# **BUILDING CODE OF AUSTRALIA COMPLIANCE ASSESSMENT REPORT**

## **PROPOSED MIXED-USE HIGH-RISE DEVELOPMENT**

**26 Elizabeth Road, Liverpool**

**REPORT NO. ► 8291 Rev 3**

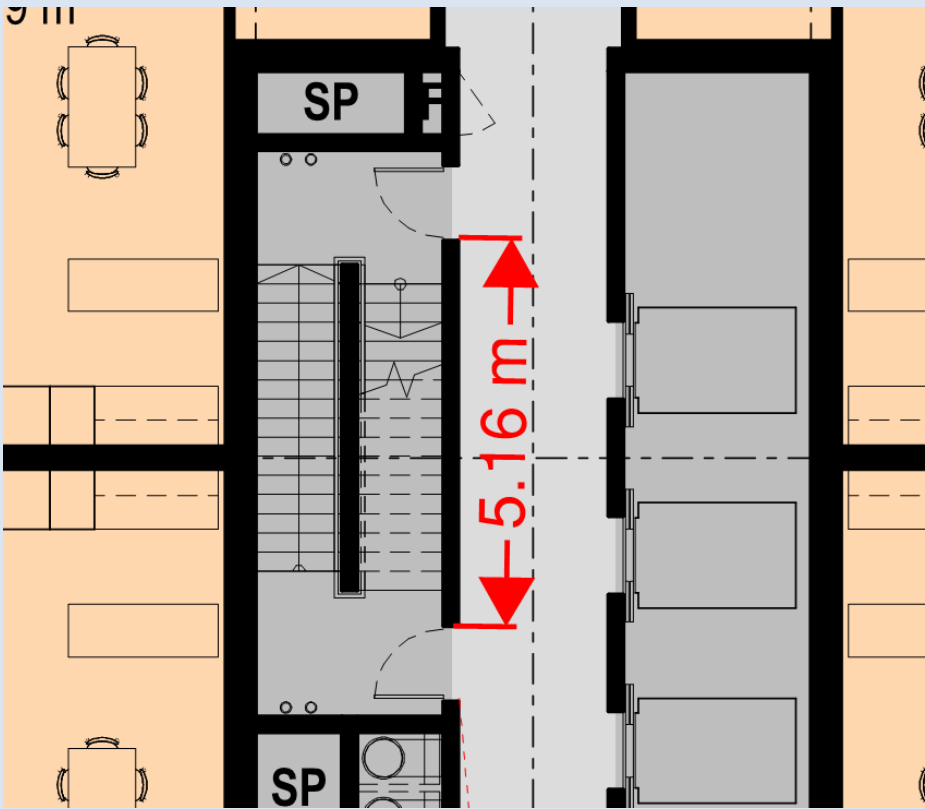
C3.2 Protection of openings in external walls				X	<p>Openings in an external wall that is required to have an FRL must be protected in accordance with C3.4:</p> <ul style="list-style-type: none"> <li>if the distance between the opening and the fire-source feature is less than 3 m from a side or rear boundary; or</li> <li>less than 6 m from the far boundary of a road, river, lake or the like adjoining the allotment, if not located in a storey at or near ground level; or</li> <li>less than 6 m from another building on the allotment that is not Class 10; and</li> </ul> <p>if required to be protected under (a), not occupy more than 1/3 of the area of the external wall of the storey in which it is located.</p> <p><b><u>Potential Compliance Issue(s):</u></b></p> <p><i>All openings within the western elevation where within 3m of the boundary are to be protected in accordance with this Clause.</i></p> <p><b><i>Details demonstrating compliance with this clause must be incorporated into the construction certificate plans / specification.</i></b></p>

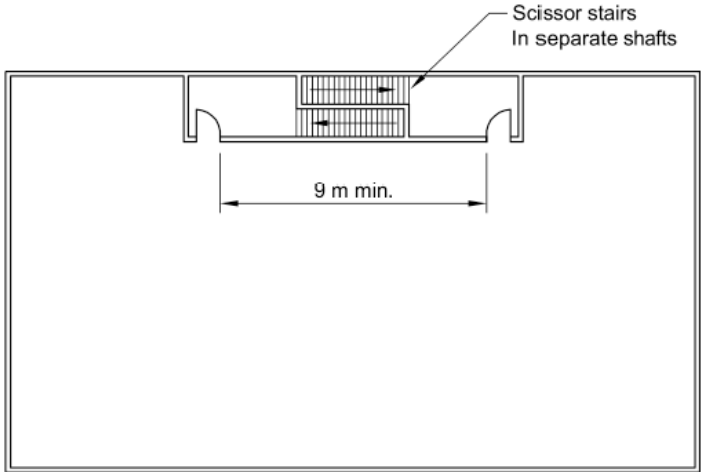
C3.3 Separation of external walls and associated openings in different fire compartments	X				<p>There are no associated openings in a different fire compartments within the building.</p>
C3.4 Acceptable Methods of Protection				X	<p>Any protection required by C3.2 must accord with the following:</p> <p><b><u>Doorways:</u></b></p> <ul style="list-style-type: none"> <li>(i) Internal or external wall-wetting sprinklers as appropriate used with doors that are self-closing; or</li> <li>(ii) –/60/30 fire doors that are self-closing.</li> </ul> <p><b><u>Windows:</u></b></p> <ul style="list-style-type: none"> <li>(i) Internal or external wall-wetting sprinklers as appropriate used with</li> </ul>

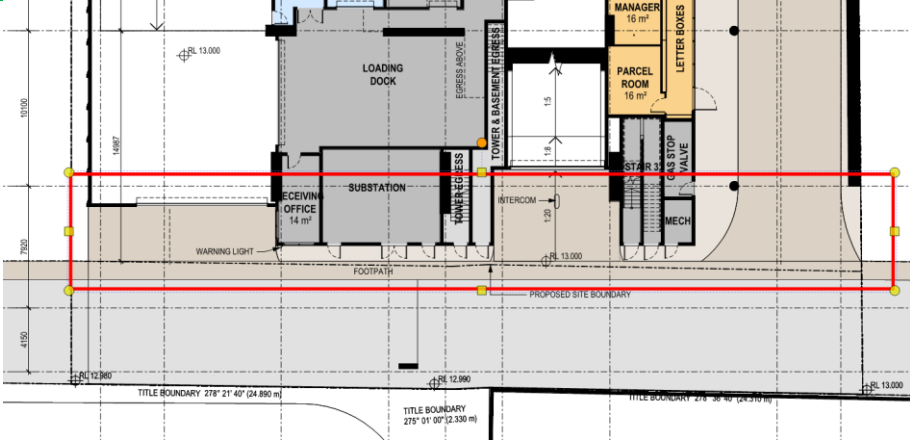
D1.17 Access to lift pits			X		<p>The lift pit depths shall be detailed on the plans to enable assessment.</p> <p>Where more than 3m in depth the following applies—</p> <p>(a) where the pit depth is not more than 3 m, be through the lowest landing doors; or</p> <p>(b) where the pit depth is more than 3 m, be provided through an access doorway complying with the following:</p> <p>(i) In lieu of D1.6, the doorway must be level with the pit floor and not be less than 600 mm wide by 1980 mm high clear opening, which may be reduced to 1500 mm where it is necessary to comply with (ii).</p> <p>(ii) No part of the lift car or platform must encroach on the pit doorway entrance when the car is on a fully compressed buffer.</p> <p>(iii) Access to the doorway must be by a stairway complying with AS 1657.</p> <p>(iv) In lieu of D2.21, doors fitted to the doorway must be—</p> <p>(A) of the horizontal sliding or outwards opening hinged type; and</p> <p>(B) self-closing and self-locking from the outside; and</p> <p>(C) marked on the landing side with the letters not less than 35 mm high:</p> <p><b>“DANGER LIFTWELL – ENTRY OF UNAUTHORIZED PERSONS PROHIBITED – KEEP CLEAR AT ALL TIMES”</b></p> <p><b><i>Details demonstrating compliance with this clause must be incorporated into the construction certificate plans / specification (and structural details)</i></b></p>
